CONTROL ROOM DESIGN REVIEW

Human Engineering Discrepancies

BEAVER VALLEY POWER STATION UNIT 2

HUMAN ENGINEERING DISCREPANCIES

F. Existing PDWST arrangement

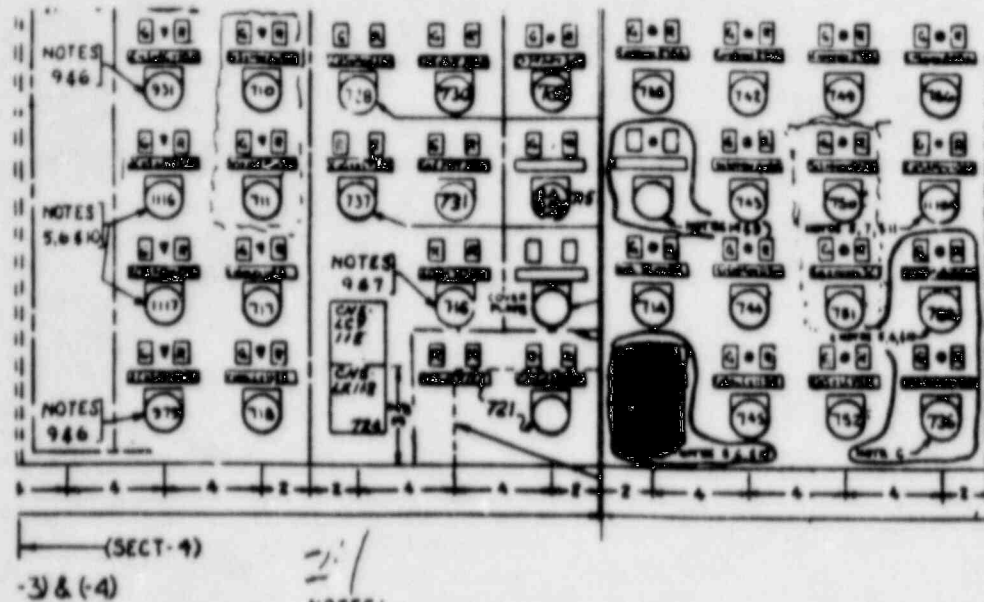
Hierarchical labeling should act as a location aid to reduce operator search time.

Indicators are separated to satisfy separation criteria (grouped by train). Some type of surface enhancement (e.g. labeling, color-coding) will assist operator. Indicators are separated by PAM Sets, the PAM Sets (2) will be demarcated in some way to further assist operator.

ITEM F LEAVE AS IS; panel is symmetrical for PSM.
all other changes approved

Existing } Atmospheric Steam Dump Valve Controllers
Arrangement }

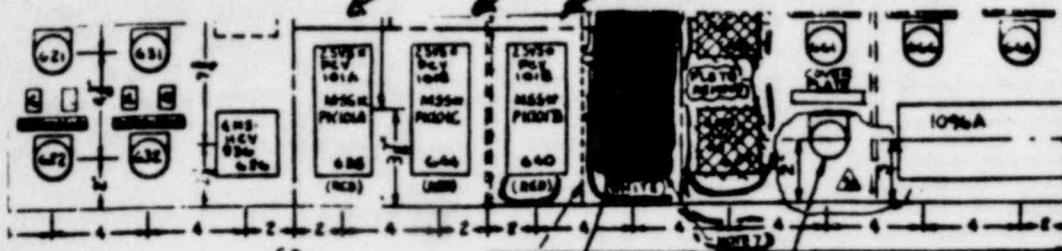
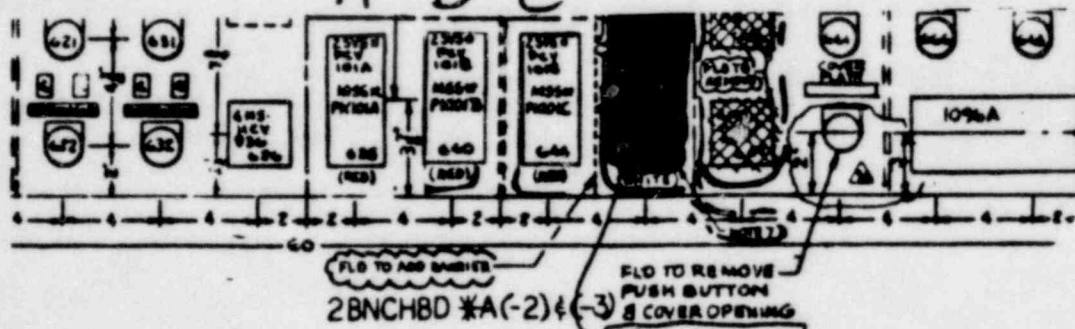
Suggested
Arrangement

TITLE FIGURE 3-1 RECOMMENDED REARRANGEMENT OF SWITCHES					CLIENT	
	BY	DATE						PROJECT	
PREPARED								J.O. NO.	
CHECKED								① ISSUED BY	
APPROVED								DATE	
REVISIONS BY		②	③	④	⑤	⑥	NUMBER		
DATE

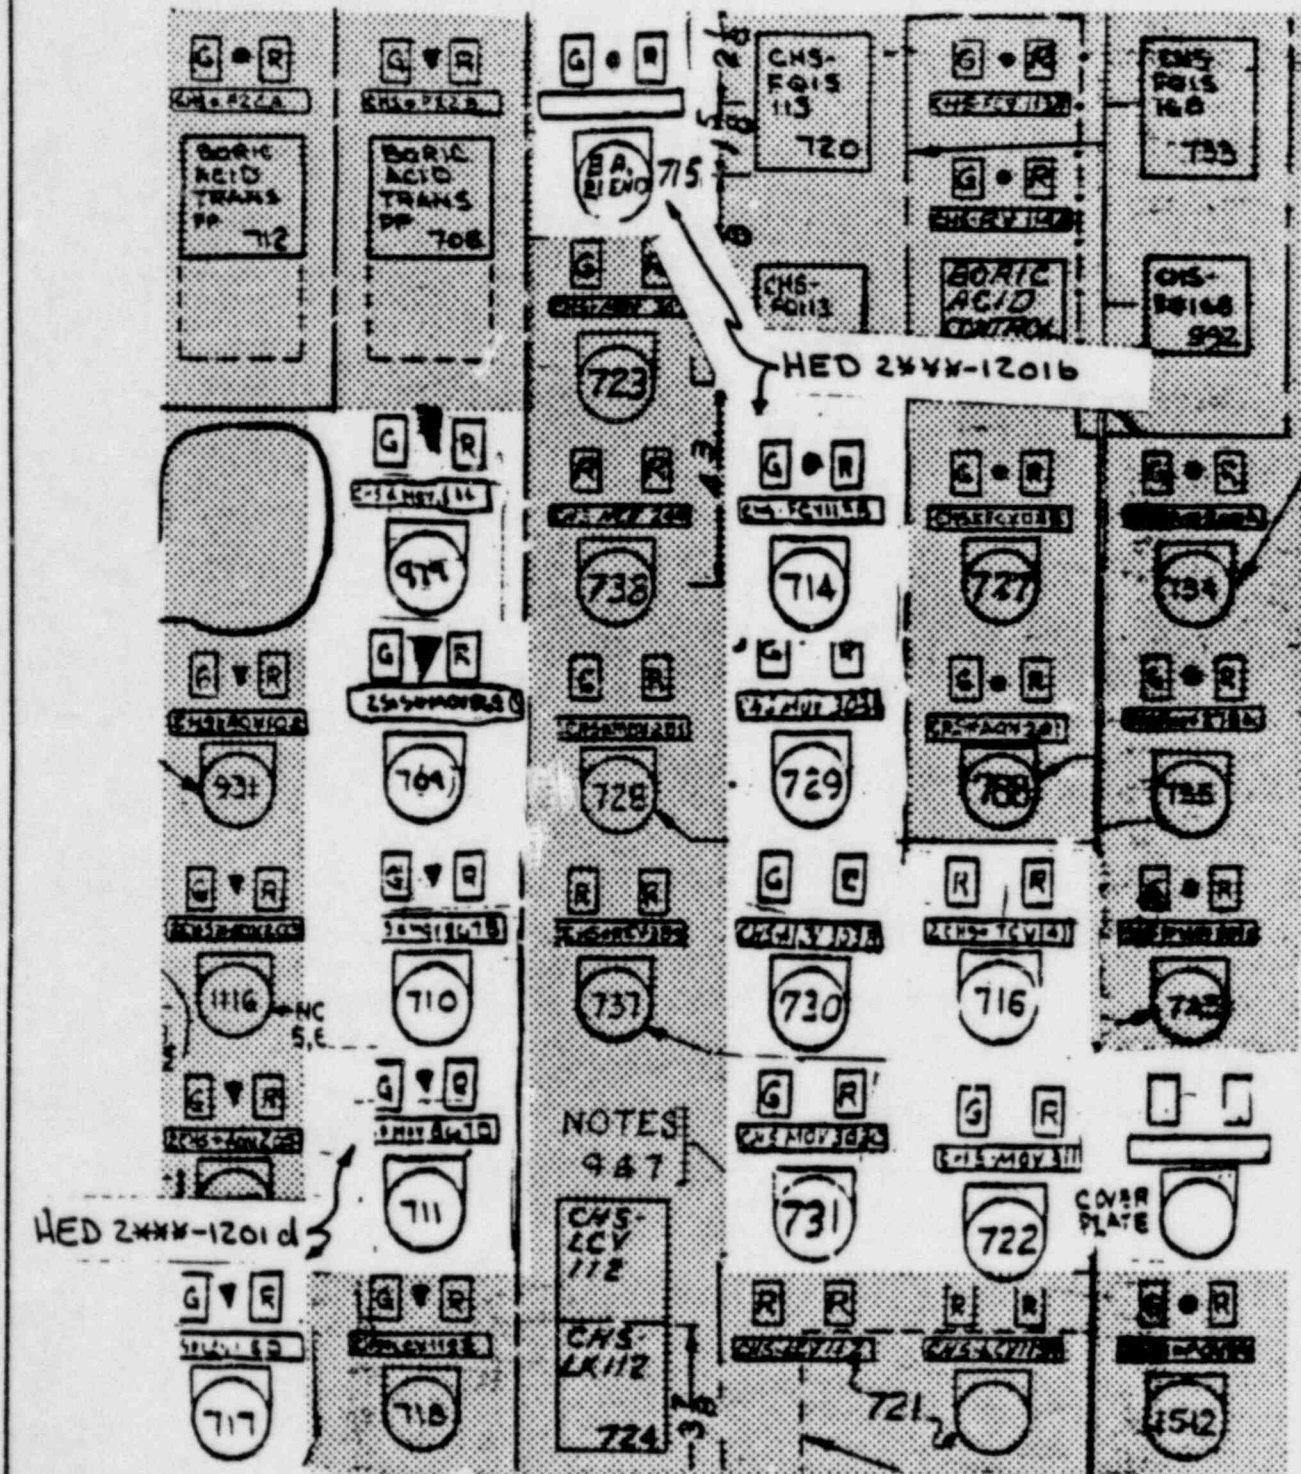
Arrangement should take into consideration the arrangement of corresponding controls in Unit 1. For g) on attached sheets, the arrangement of these controls on the ESP is correct. MCBs should match the ESP arrangement.

HED No. 2***-1201 G

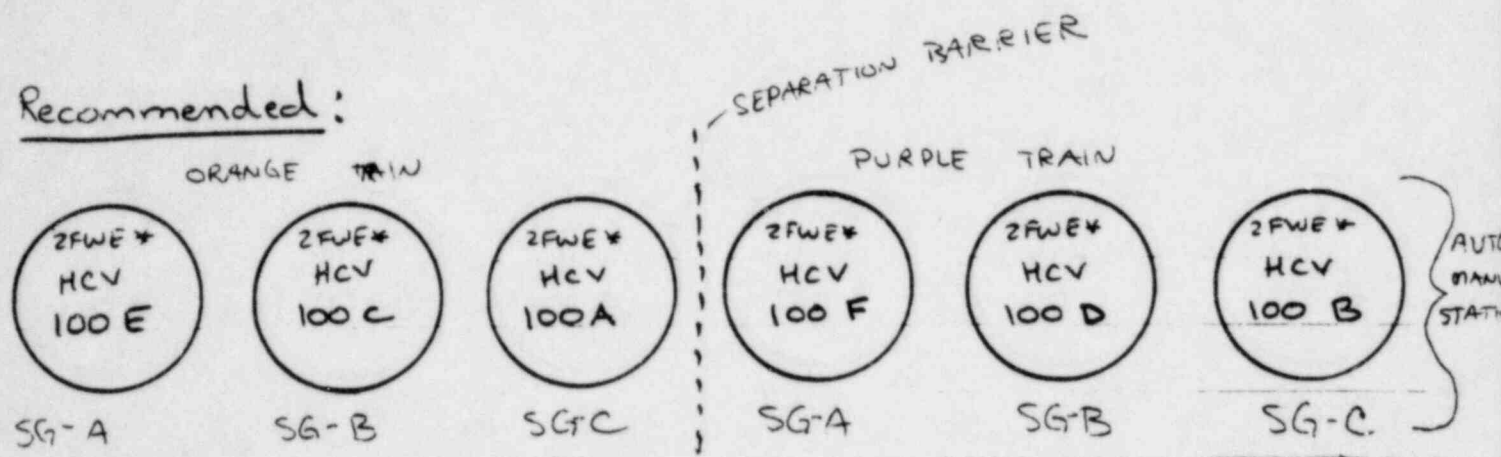
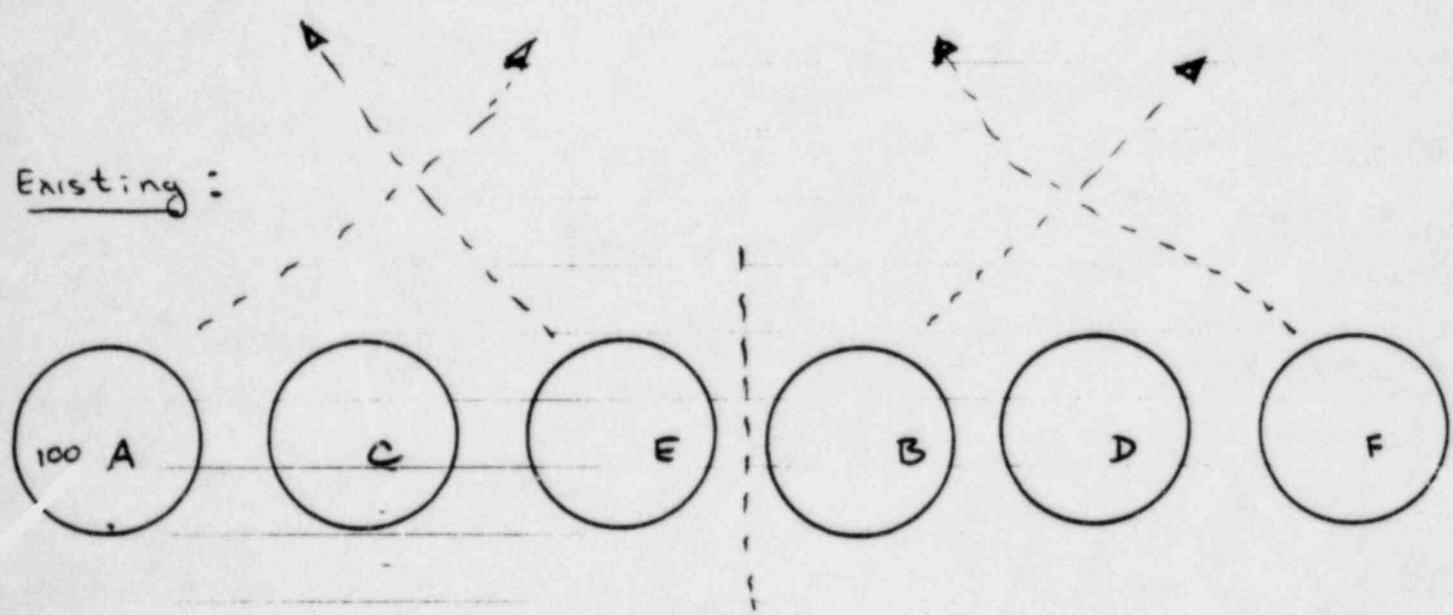
G. Recommended arrangement for
Aux. Feedwater valve controllers is as shown
below (matches existing ESP arrangement):

TITLE				CLIENT	
		FIGURE 3-2				PROJECT	
		Recommended Rearrangement of				J.O. NO.	
		Switches				ISSUED BY	
						DATE	
PREPARED	BY	DATE					NUMBER
CHECKED	PEL						
APPROVED							
REVISIONS BY	②	①	③	④	⑤		
DATE

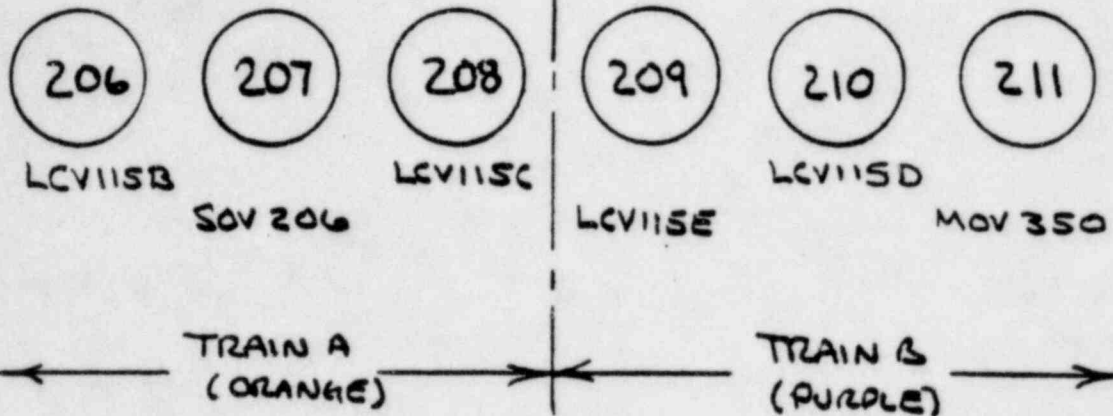
1. All mark numbers preceded by ZCHS*
2. REFER to EMERGENCY SHUTDOWN Panel Section 2
Drawing RE-25DF

Agree to implement

CLARIFICATIONS TO HED NO. Z***-3002

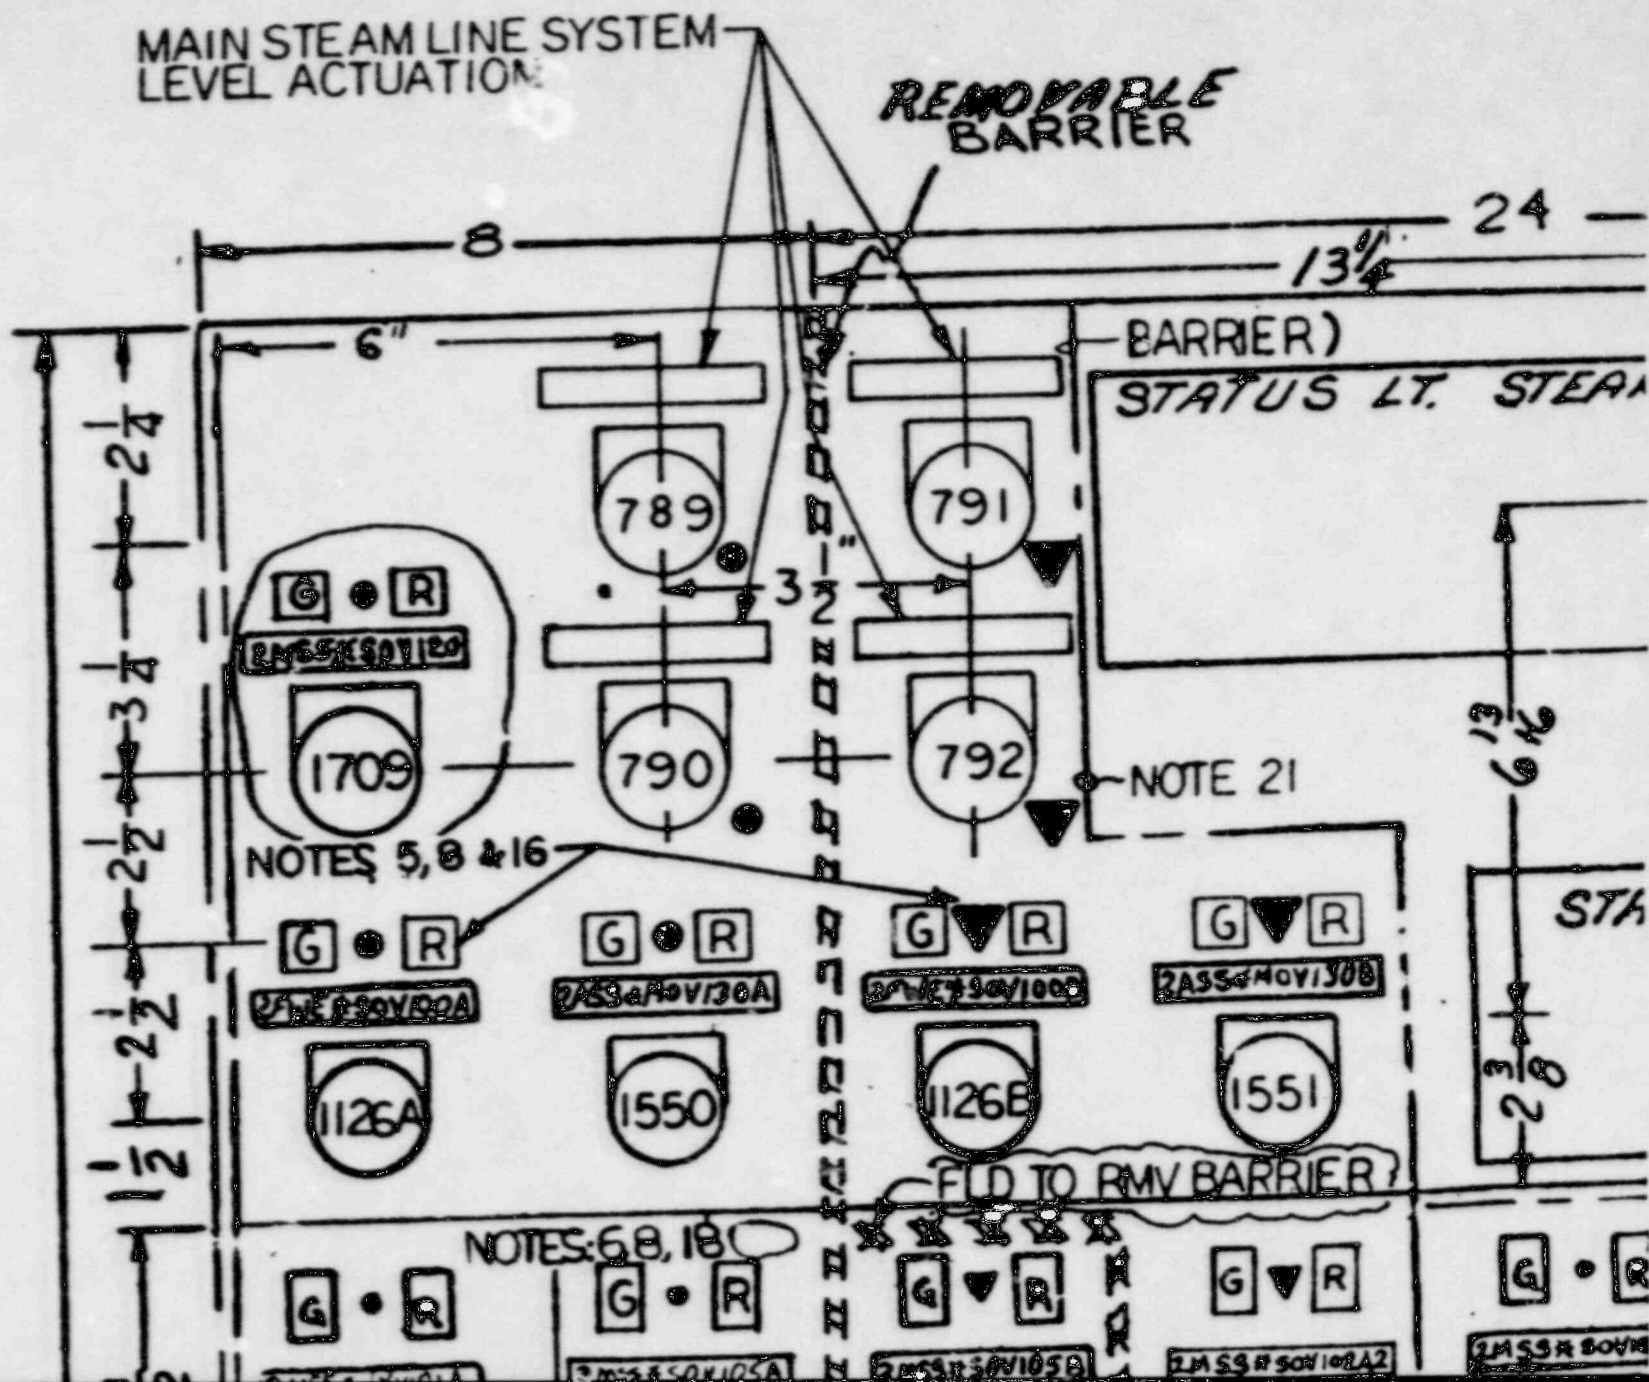
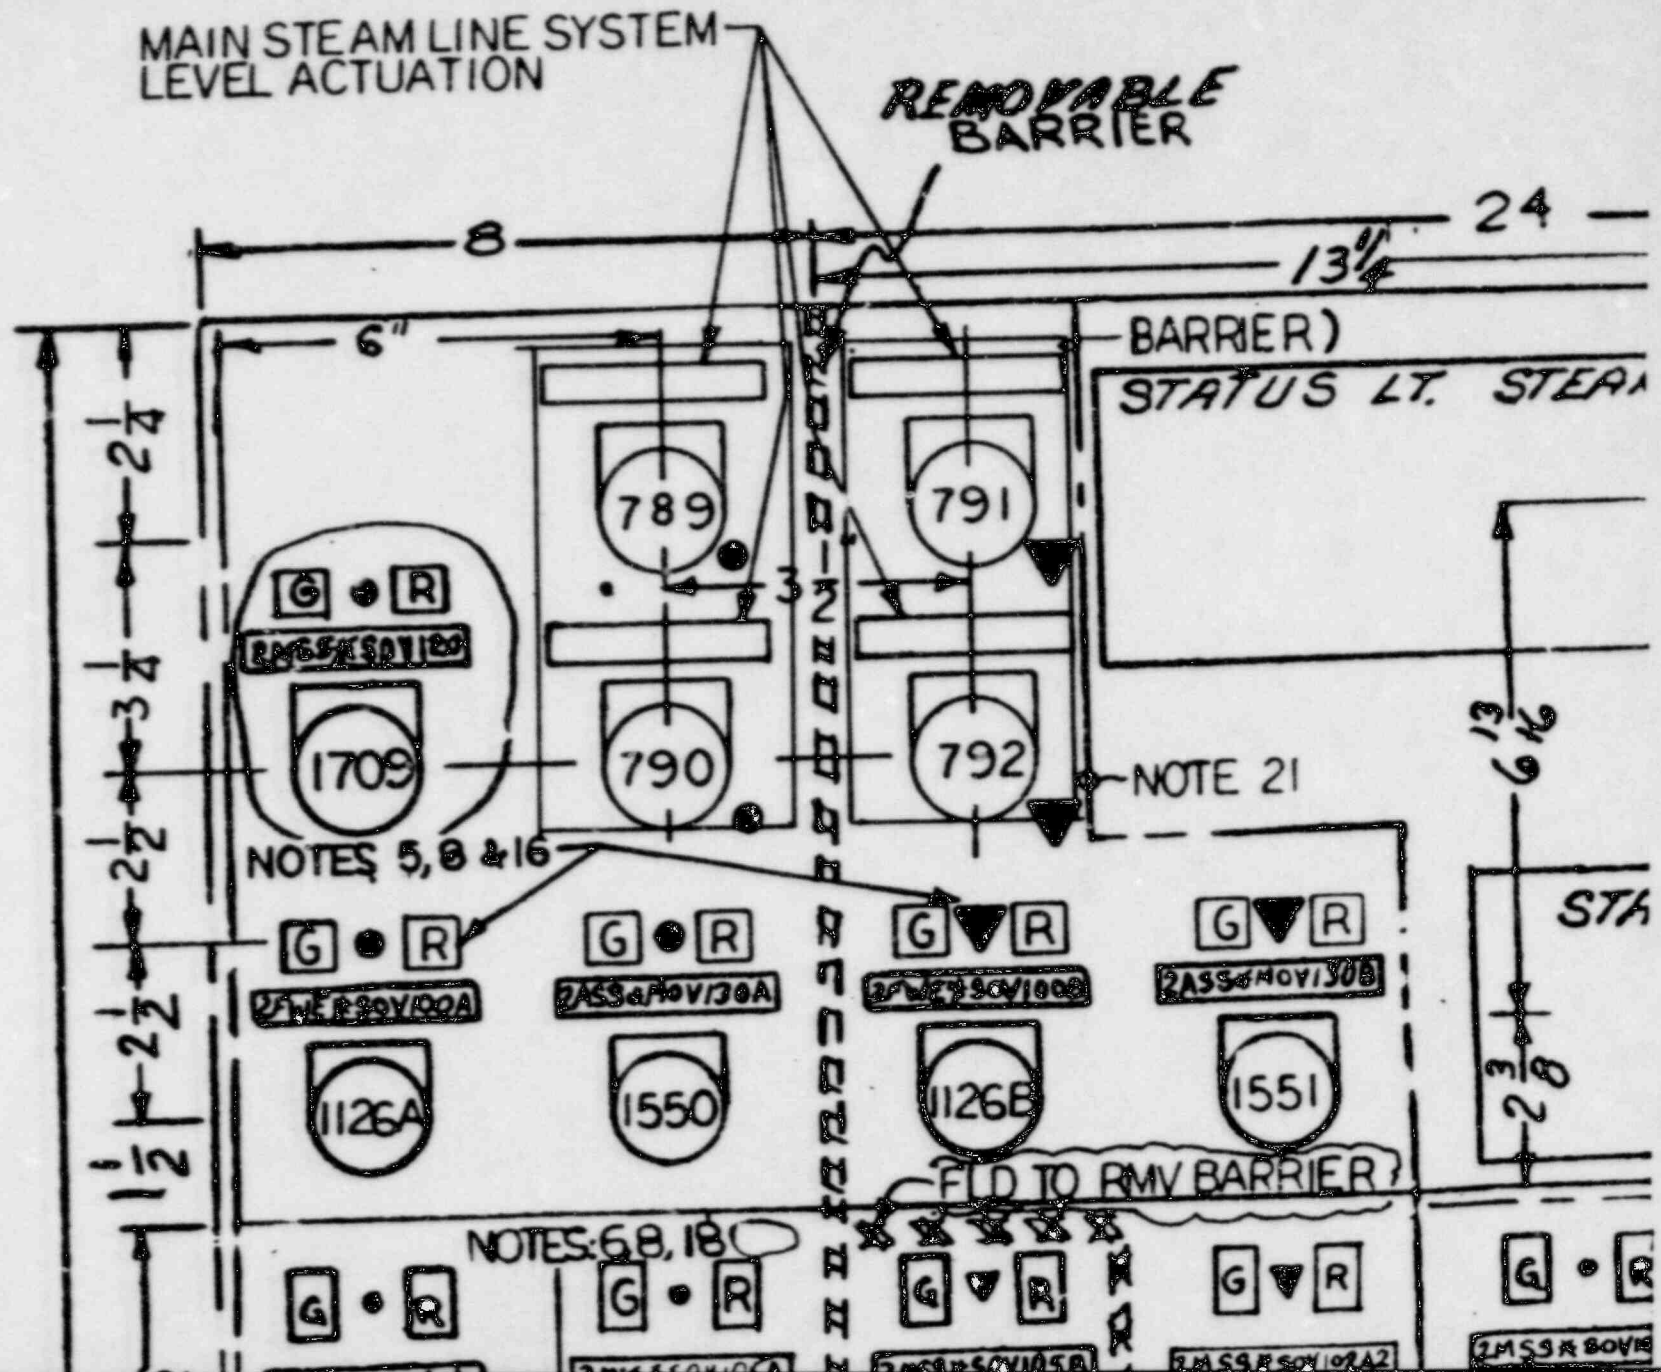
THE STATEMENT IN THE "REVIEW AND DISPOSITION" SECTION OF THE HED IS ~~THE~~ VAGUE BUT IMPLIES THE EXISTING NAMEPLATE WORDING IS INCORRECT OR INADEQUATE. THE WORDING LISTED ABOVE, HOWEVER, IS CORRECT AND APPEARS CLEAR. THEREFORE, NO CHANGE IN THE NAMEPLATE WORDING IS RECOMMENDED.

THE "REVIEW AND RECOMMENDATIONS" SECTION OF THE HED RECOMMENDS THAT ~~APPROPRIATE~~ LABELING BE ADDED TO THE BENCHBOARD TO INSTRUCT THE OPERATORS TO PRESS BOTH BUTTONS FOR A GIVEN TRAIN SIMULTANEOUSLY TO INITIATE MAIN STEAMLINE ISOLATION. WORDING TO THIS EFFECT COULD BE ADDED TO THE BOARD. IF OPERATIONS BELIEVES THIS TO BE A WORTHWHILE AID, IN ADDITION TO OPERATOR TRAINING, IT CAN BE ADDED. BESIDES THIS OPERATOR AID OR AS AN ALTERNATIVE TO IT SOME TYPE OF PAINTING OR TAPING OF THE BENCHBOARD SHOULD BE CONSIDERED TO DEMARCATATE THESE

CONTROLS. SHEET 3 OF THIS ATTACHMENT SHOWS THE PRESENT ARRANGEMENT OF ITEMS 789, 790 (TRAIN A) AND 791, 792 (TRAIN B). SHEET 4 SHOWS A SUGGESTED DEMARCATING OF THESE CONTROLS USING TAPE TO GROUP THEM AND OFFSET THEM FROM THE REMAINDER OF THE BOARD.

THE CONTROL ROOM REVIEW TEAMS FOR BV-1 AND BV-2 SHOULD ATTEMPT TO MAKE ANY BOARD ENHANCEMENTS FOR THESE CONTROLS AS SIMILAR AS POSSIBLE.
